World Forum for Harmonization of Vehicle Regulations**Working Party on Brakes and Running Gear****Seventy-sixth session**

Motorcycle braking – Regulation No. 78**Proposal for amendments to Regulation No. 78 (Uniform provisions concerning the approval of vehicles of categories L₁, L₂, L₃, L₄ and L₅ with regard to braking)****Submitted by the expert from the International Motorcycles Manufacturers Association***

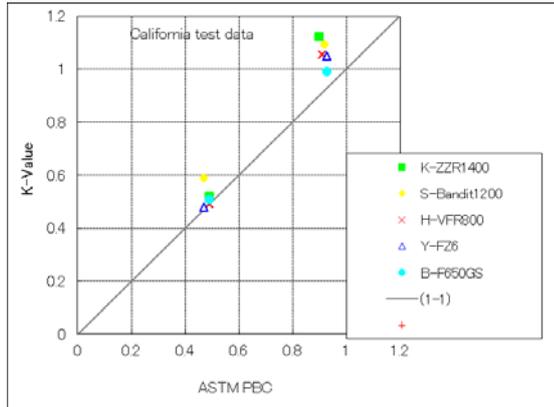
- (c) During GTR3 discussions, the correlation test between K-method and ASTM method was performed in California. The data from the test are shown in the graph below.

PBC values by K-method were for same course, and the following were recognized.

- PBC values were different by measuring motorcycle (tyre).
- Such level of difference should be permitted.

It was recognized that even for the same course PBC values were different for each motorcycle. It was noted that it is beneficial to measure the PBC values of the course using the same motorcycle to maintain the course PBC value condition.

Note 1: A representative vehicle may be acceptable for PBC measurement by method (b) if that vehicle has shown the same nominal PBC on both high μ and low μ as previously determined by method (a).

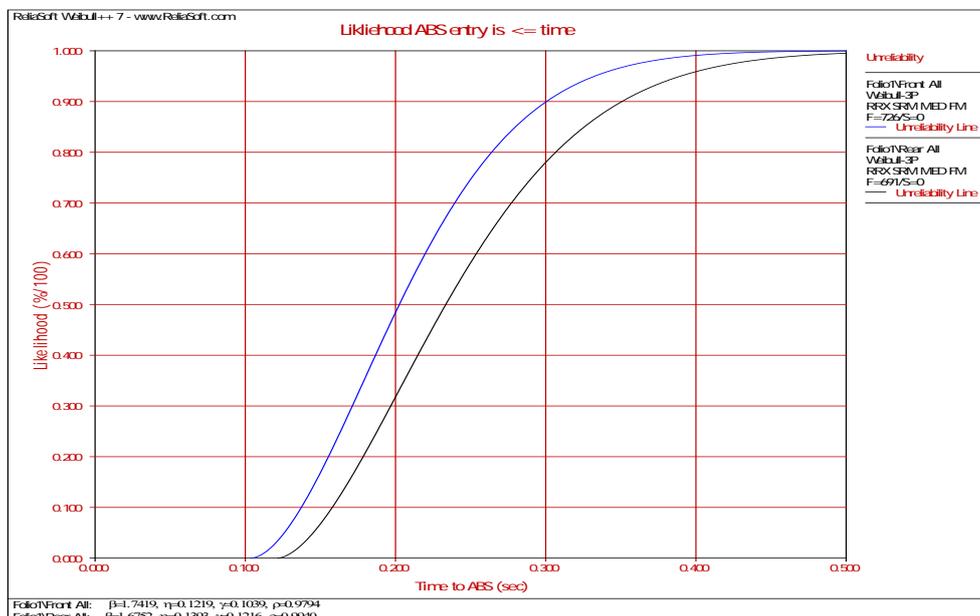
It has been noticed in testing that the brake application rate specified in section 4.9.5.1 can result in a large number of test failures. It can be seen in the chart below that the 0.2 second lower limit shows a failure rate is between 30 per cent and 50 per cent of the time.

By reducing the lower limit to 0.1 seconds, the test failure rate reduces to practically zero. Allowing the reduction tends to make the regulation more stringent by including a greater number of brake force application rates and eliminates restrictive test requirements.

- (f) Brake application rate:
The brake control actuation force is applied in ~~0.2~~ **0.1** – 0.5 secs.
- ...
- 9.6. Wheel lock check - high to low friction surface transition:
